PG&E Letter DCL-16-025

Docket No. 50-275, OL-DPR-80
Docket No. 50-323, OL-DPR-82
Diablo Canyon Units 1 and 2

Pacific Gas and Electric Company's Sixth Six-Month Status Report in Response to
March 12, 2012, Commission Order Modifying Licenses with Regard to
Requirements for Mitigation Strategies for Beyond-Design-Basis External Events
(Order Number EA-12-049)

**Pacific Gas and Electric Company's Sixth Six-Month Status Report for the
Implementation of NRC Order EA-12-049**

Figure 6E
RHR Crosstie Connection Point
Unit 1

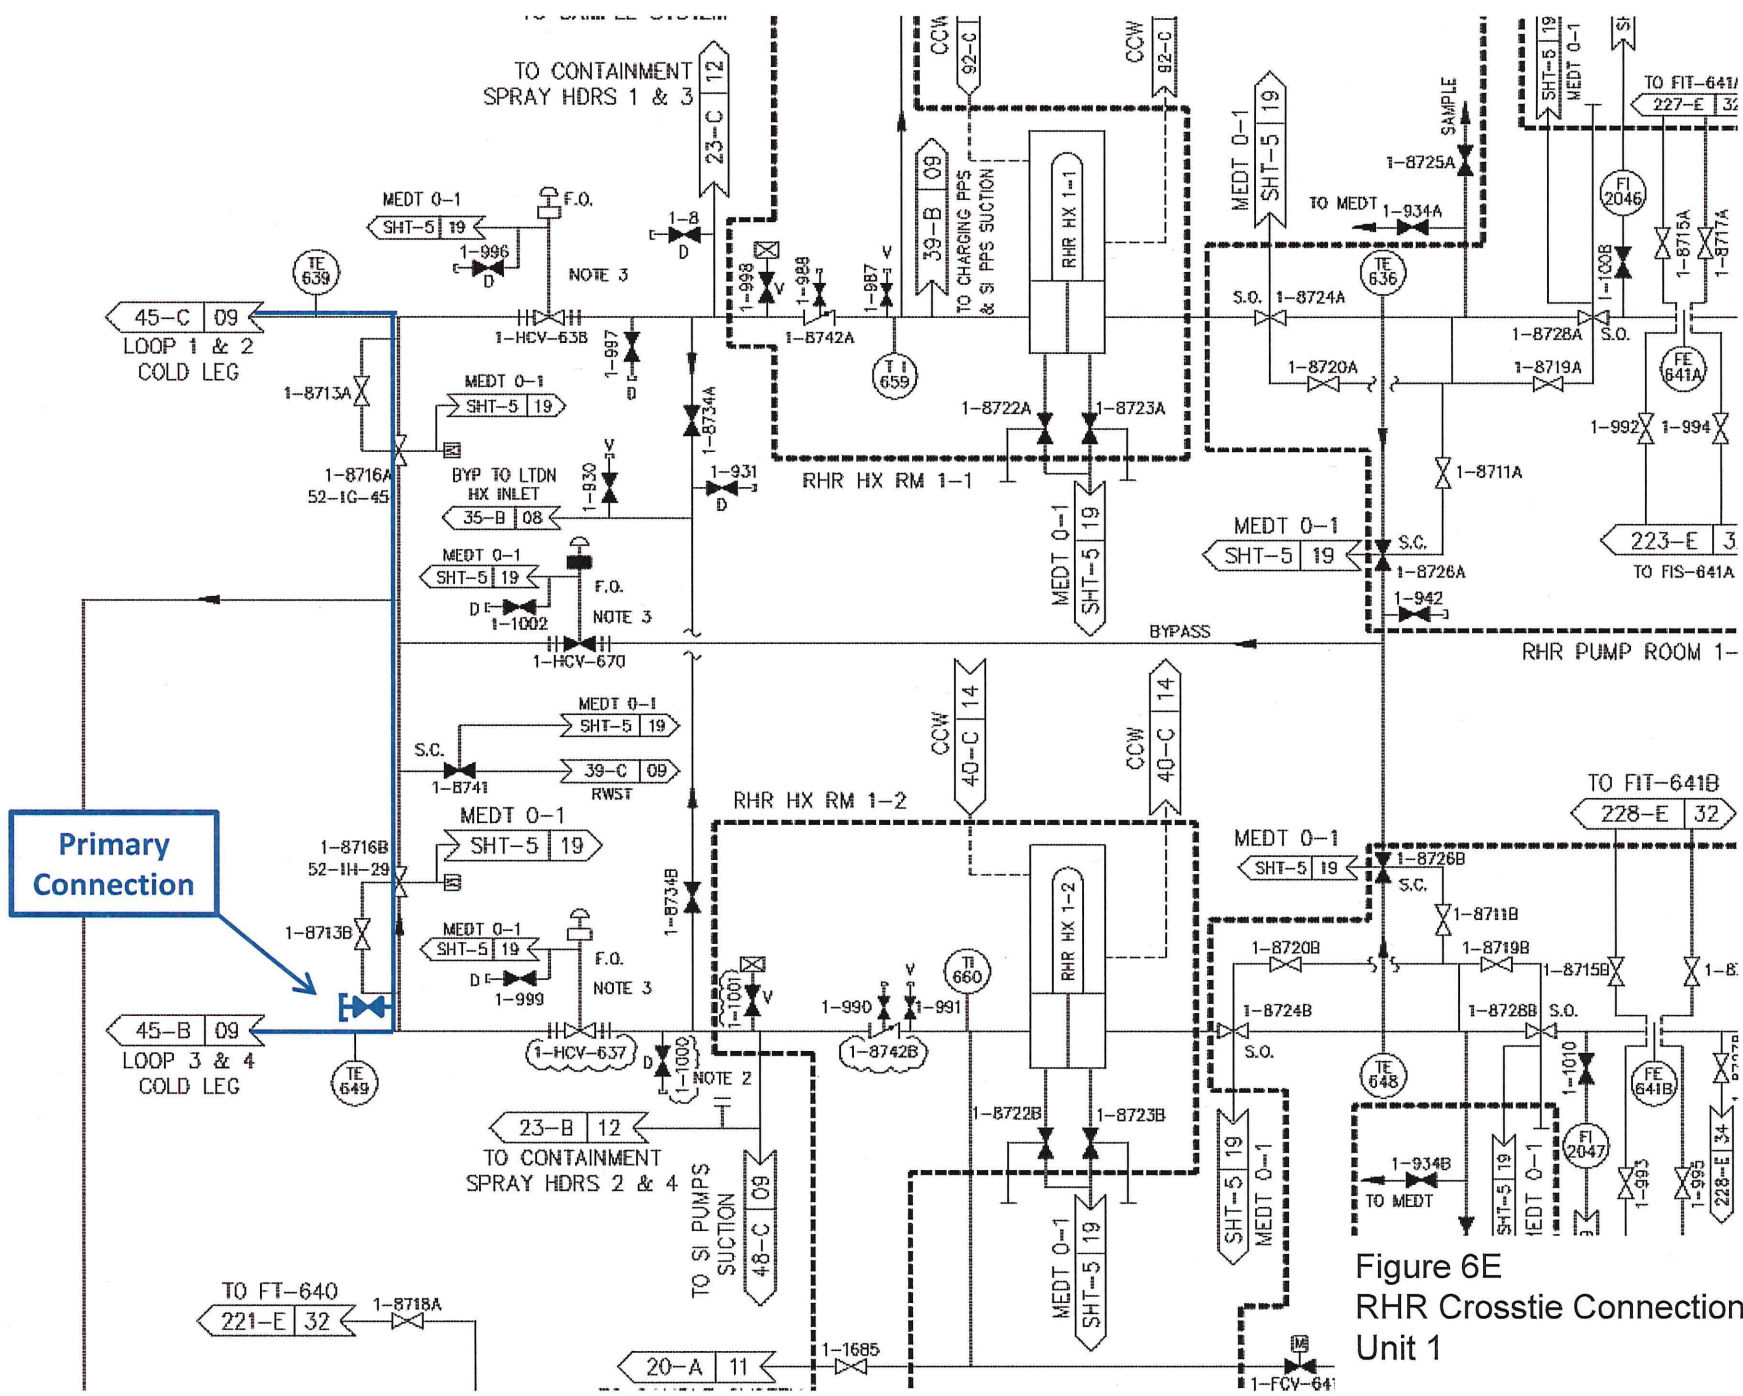
1. Updated Figures 6E and 7E to more accurately reflect new FLEX connection in RHR system.
2. Updated Figures 8C and 9D to more accurately show the EAFW pump discharge hose routing in the safety injection pump room, and identify the connection point (Check Valves SI-1-8922A and SI-2-8922A).
3. Updated Figures 10 and 11 to more accurately reflect new FLEX connection in the chemical and volume control system.
4. Updated Figures 16 and 17 to more accurately reflect how SFP hose is fastened.
5. Updated Figures 21 and 22 to correct typo ("sliced" should be "spliced").
